Lease Serial No.
NMNM65441**SUNDRY NOTICES AND REPORTS ON WELLS**
Do not use this form for proposals to drill or to re-enter an abandoned well. Use form 3160-3 (APD) for such proposals.**SUBMIT IN TRIPLICATE - Other instructions on page 2**

Wellbore Schematic Well Name: MADERA 25 FEDERAL 1

**Permanent Abandonment of Federal Wells
Conditions of Approval (LPC Habitat)**

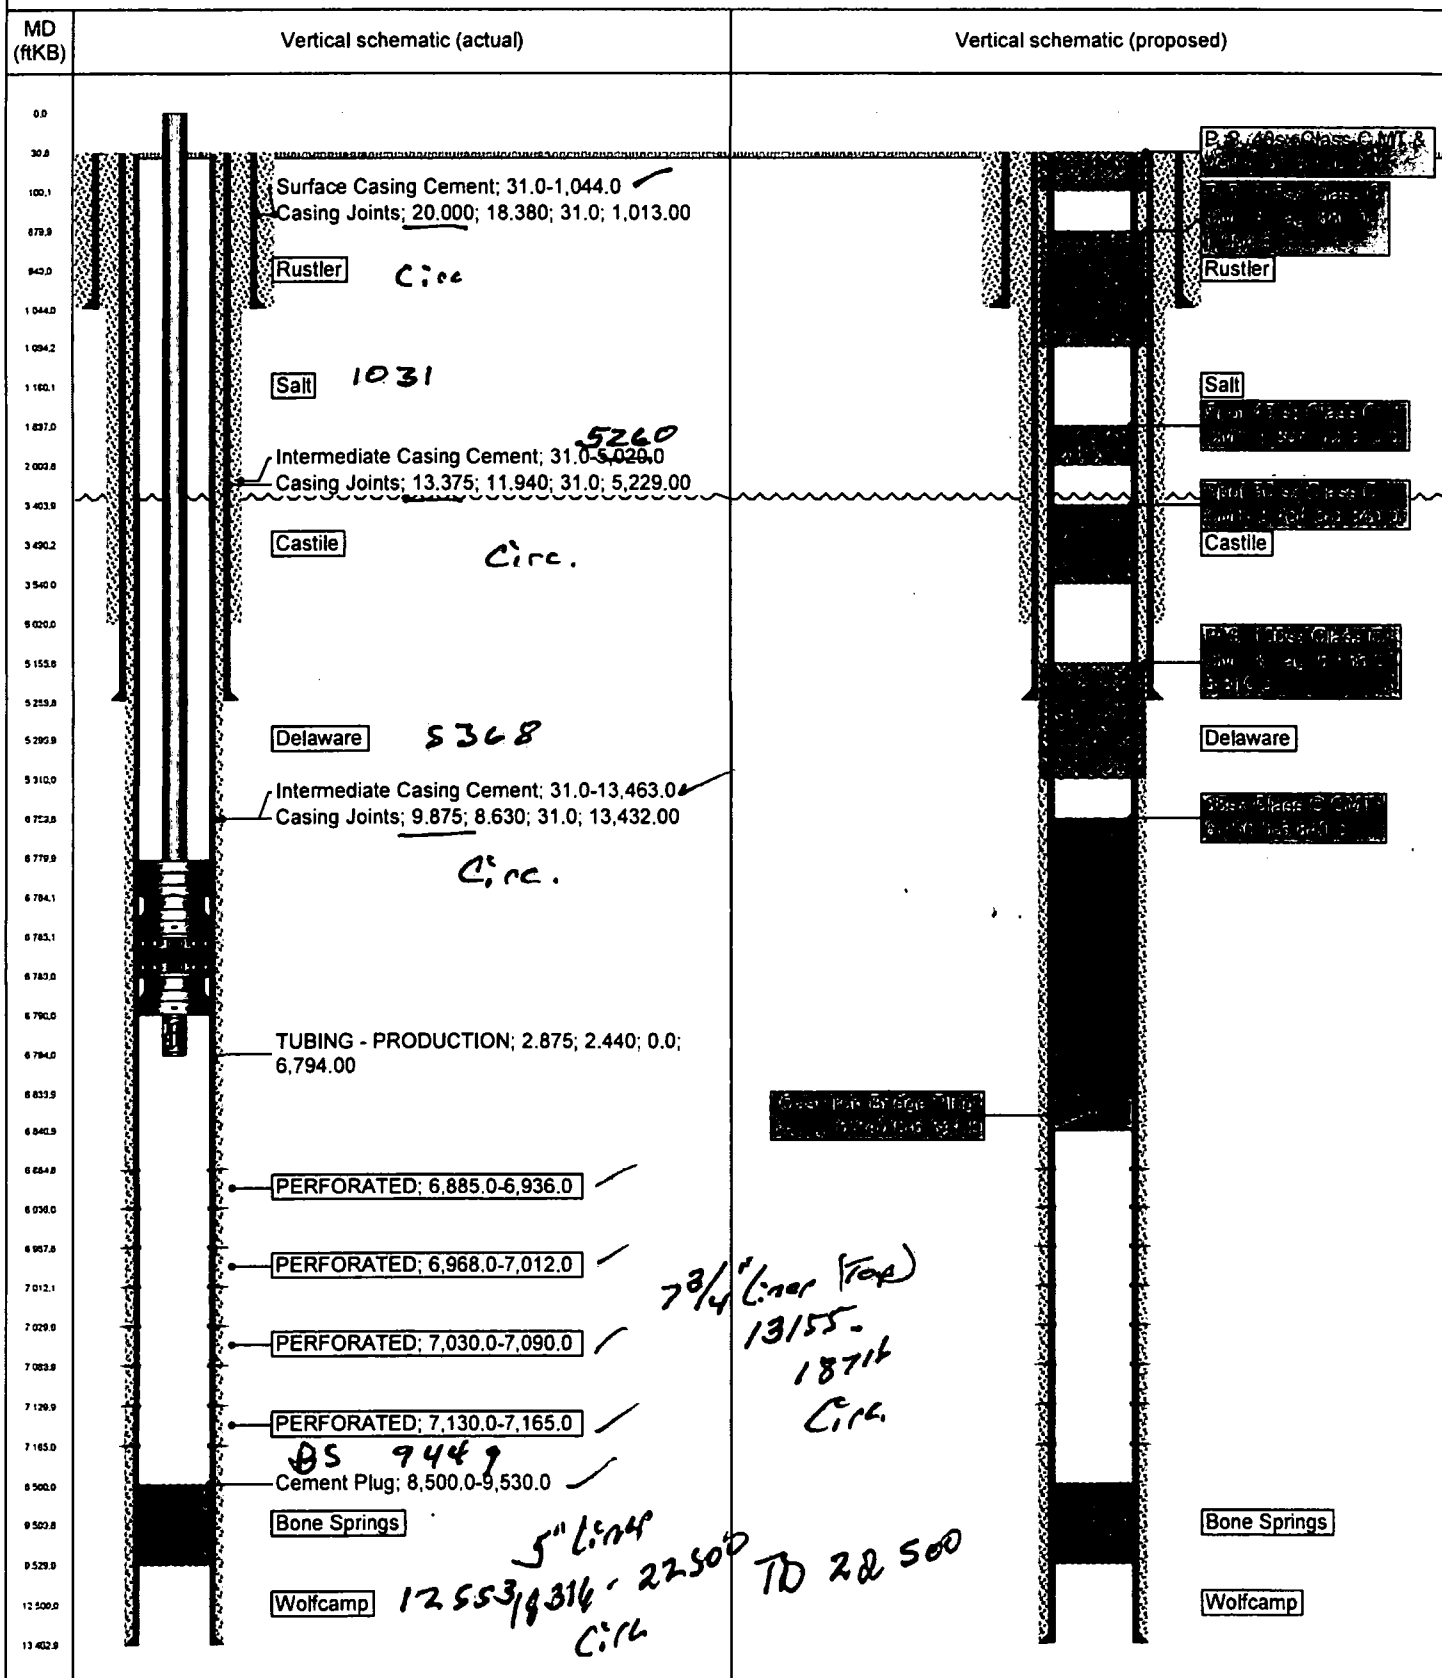
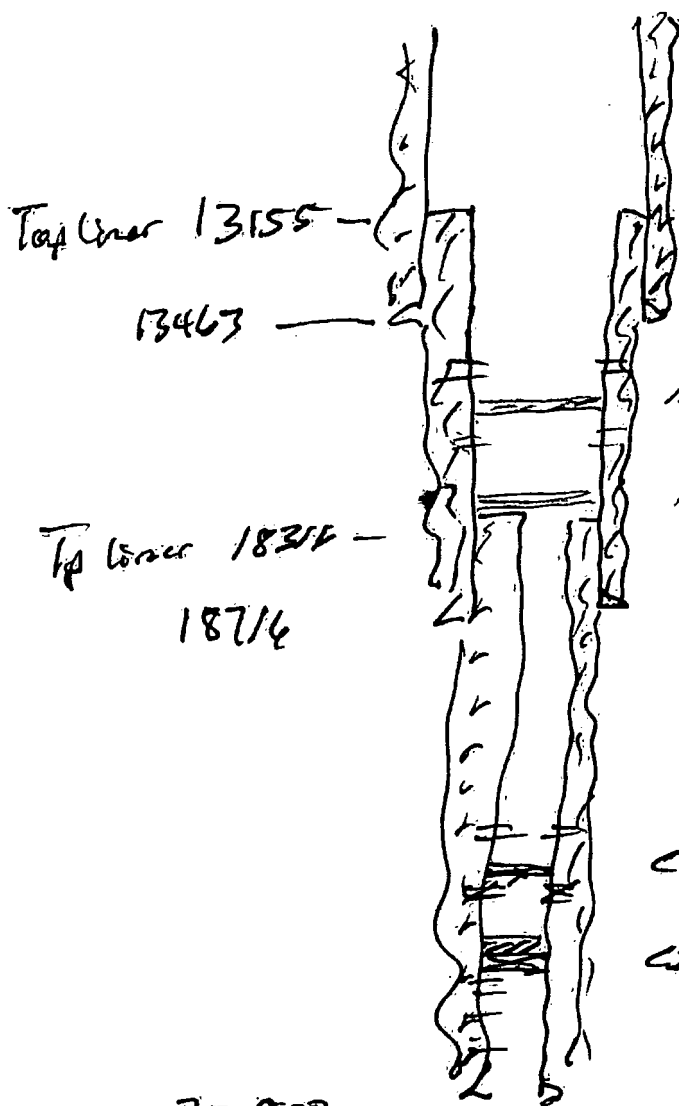
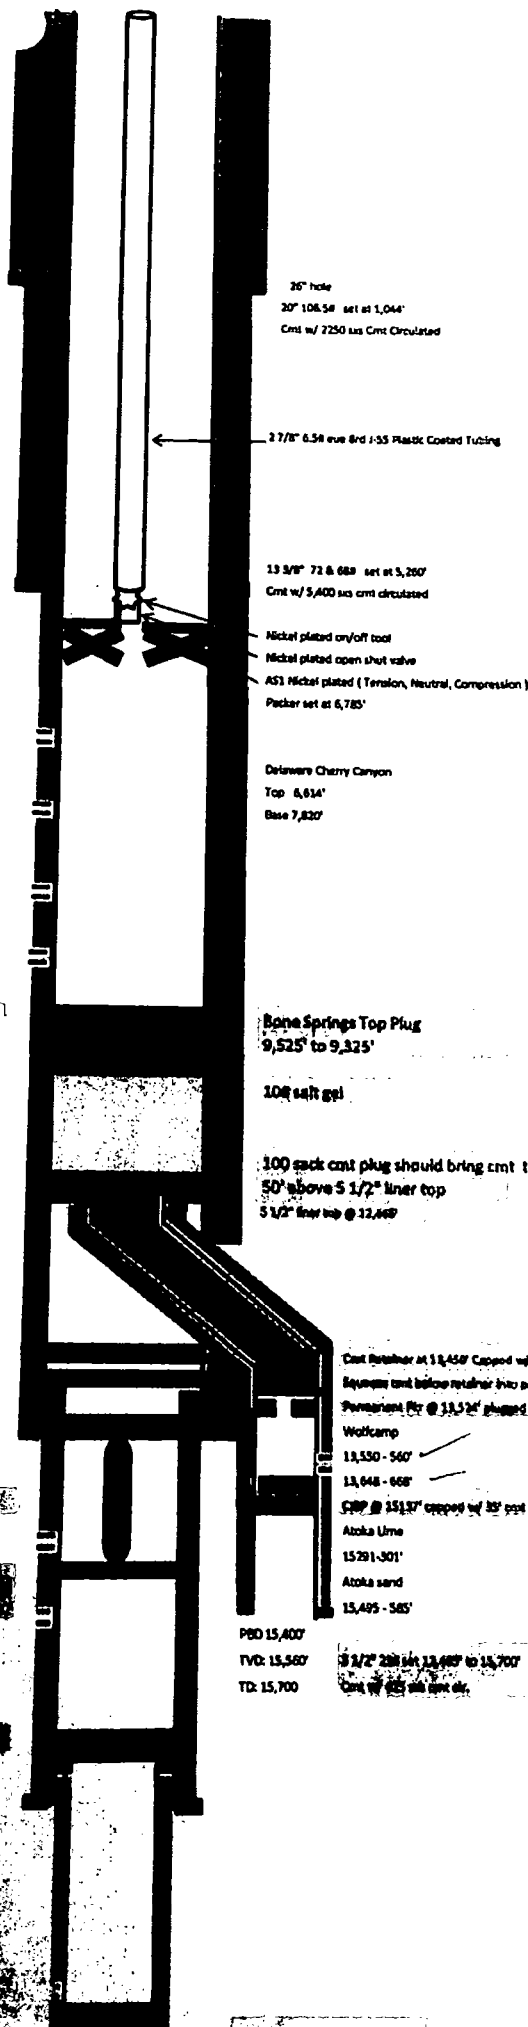
- 1) Set CIBP @ 6,840'; Tag Same
- 2) Spot 35sx Class C CMT @ 6,840' - 6,760' on CIBP 6670
- 3) P. S. 100sx Class C CMT @ 5,310' - 5,156'; WOC and Tag Same
- 4) Spot 50sx Class C CMT @ 3,540' - 3,404'
- 5) Spot 40sx Class C CMT @ 2,010' - 1,897'
- 6) P. S. 115sx Class C CMT @ 1,094' - 880'; WOC and Tag Same
- 7) P. S. 40sx Class C CMT @ 100' - Surface; WOC and Verify Same
- 8) Install Below Ground Dry Hole Marker

**** BLM REVISED ** BLM REVISED ** BLM REVISED ** BLM REVISED ** BLM REVISED ******FOR RECORD ONLY FOR RECORD ONLY**

4. Mud Requirement: Mud shall be placed between all plugs. Minimum consistency of plugging mud shall be obtained by mixing at the rate of 25 sacks (50 pounds each) of gel per 100 barrels of brine water. Minimum nine (9) pounds per gallon.

5. Cement Requirement: Sufficient cement shall be used to bring any required plug to the specified depth and length. Any given cement volumes on the proposed plugging procedure are merely estimates and are not final. Unless specific approval is received, no plug except the surface plug shall be less than 25 sacks of cement. Any plug that requires a tag will have a minimum WOC time of 4 hours.

In lieu of a cement plug across perforations in a cased hole (not for any other plugs), a bridge plug set within 50 feet to 100 feet above the perforations shall be capped with 25 sacks of cement. If a bailer is used to cap this plug, 35 feet of cement shall be sufficient. Before pumping or bailing cement on top of CIBP, tag will be required to verify depth. Based on depth, a tag of the cement may be deemed necessary.
